LINCOLN CITY/LANCASTER COUNTY PLANNING STAFF REPORT

DATE: December 18, 2001

P.A.S.: Change of Zone #3297 (R-4, B-2, and O-3 to R-3)
Change of Zone #3298 (R-3 to R-4, B-2 and O-3)
Preliminary Plat # 00029 Pine Lake Heights South 4th Addition
Use Permit #134

SHEET 2 OF 14

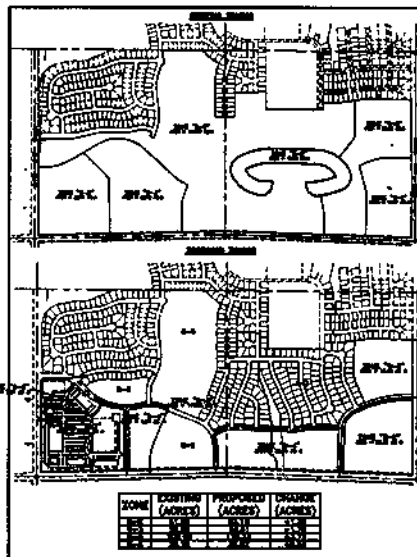
2. A 16' trail easement is provided to extend the trail system from Cavett Elementary School to Yankee Hill Road. This easement needs to be increased to 20' in width, and moved so it is located between Lots 9 and 10, Block 5. Moving it one lot to the west would then require only one street crossing at this location, instead of two as it is currently configured. The trail also must be offset from the street at Lots 12 and 13, Block 7 so it is adjacent to property lines and provides separation from the street. Additionally, the detail/cross section of the trail crossing at Grainger Parkway must be removed from Sheet #2, with the eventual design subject to approval of the Public Works Department.

- 1.1.6 Delete the "proposed" zoning remarks.
 - 1.1.7 Delete the detail/cross section of the pedestrian-bike trail crossing from Sheet #2, and add a note indicating that the crossing design is to be approved by the Public Works Department.

ZONING EXHIBIT

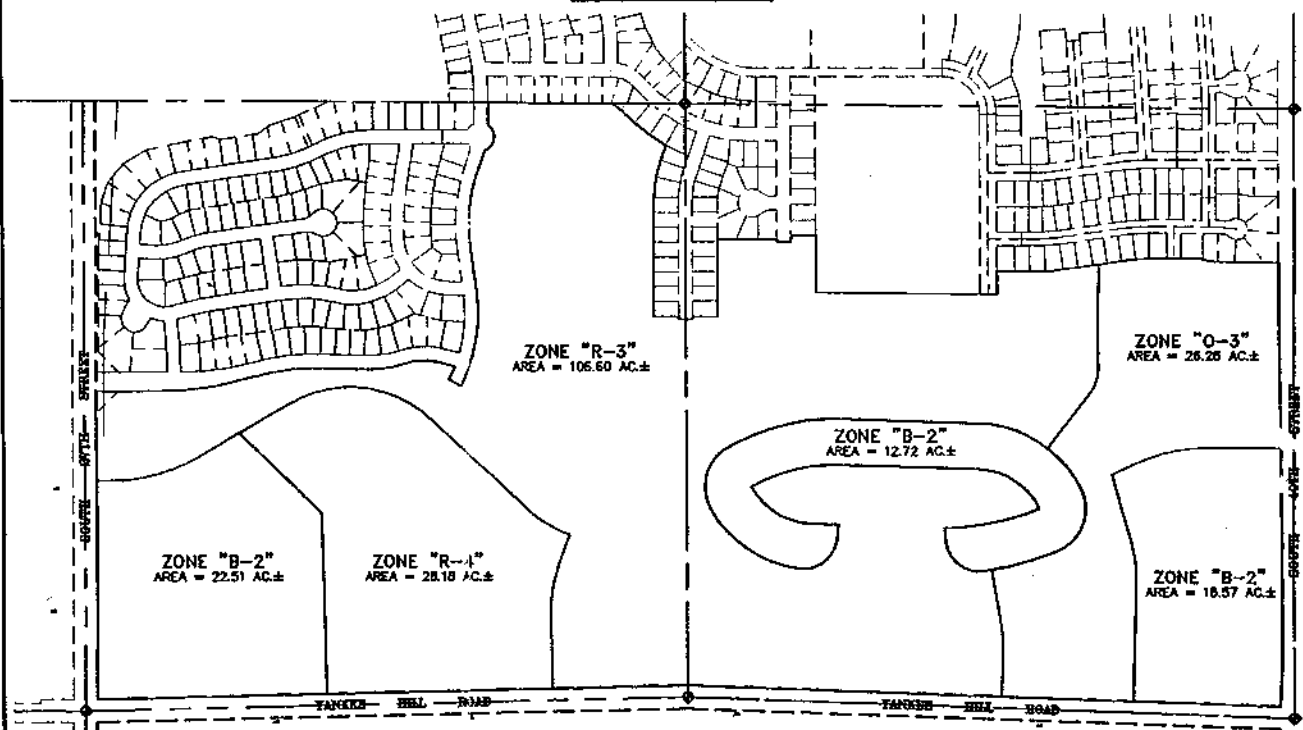
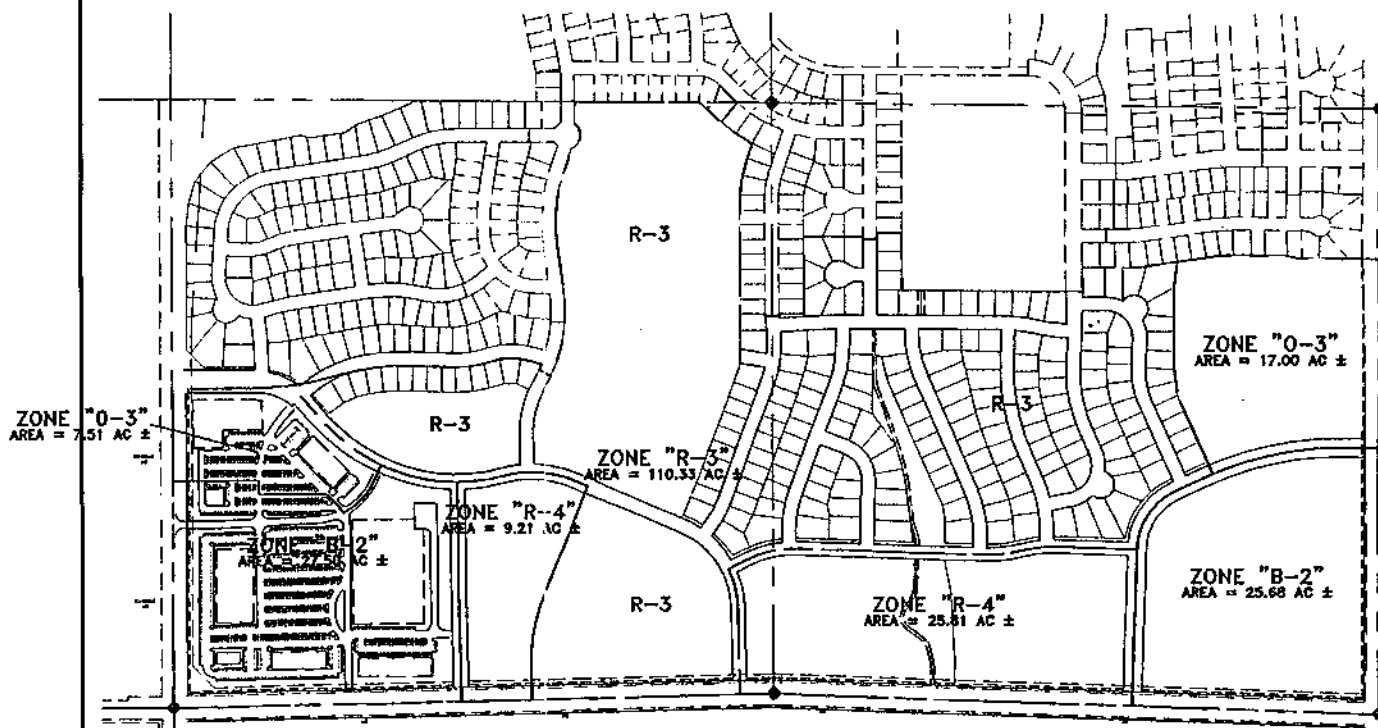
1. This change of zone must be revised to provide an O-3 buffer between the B-2 and R-3 districts at South 40th Street and Yankee Hill Road.
